**SUBJECT:      RECALL R14XE**  
**STEERING SHAFT CLAMP MAY CONTACT RUBBER**  
**CLOSEOUT BOOT**

**R14XE**

**NHTSA RECALL NO. 14V-309 SCHOOL BUS  
NHTSA RECALL NO. 14V-306 NON-SCHOOL BUS**

# Steering Shaft Floor Boot Seal

Fig. 1

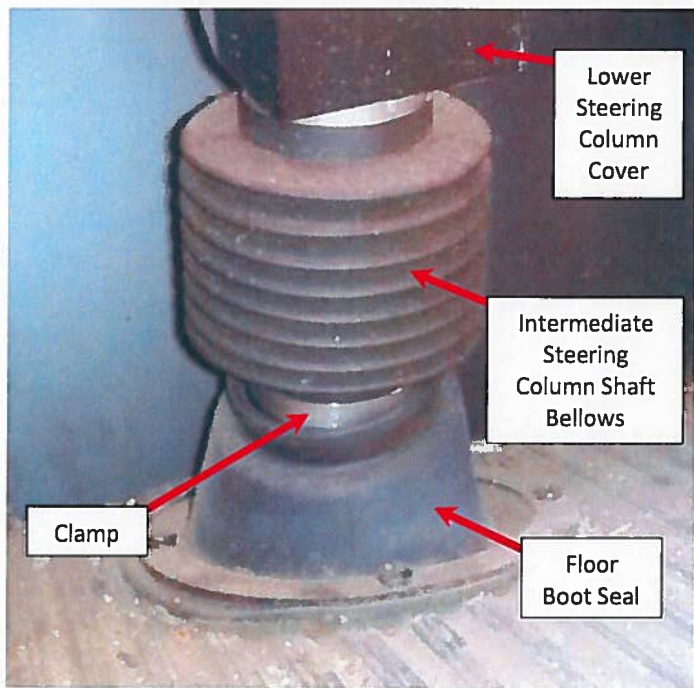
Clamp on intermediate steering column shaft bellows may contact steering shaft floor boot seal and tear floor boot seal and bind steering shaft causing difficulty in steering.

1. Park bus on a level surface, apply parking brake, turn off ignition, remove ignition key and chock rear wheels.
2. Inspect steering shaft floor boot seal for wear or damage and slit is toward front of bus.
3. If damaged or worn, complete section **Steering Shaft Floor Boot Seal Replacement** before continuing.
4. After completing section **Steering Shaft Floor Boot Seal Replacement** or if there is no damage or wear to the floor boot seal, complete section **Intermediate Steering Column Shaft Bellows Adjustment**.

Remove clamp and raise bellows on intermediate steering shaft beyond interference and secure with narrow worm gear clamp.
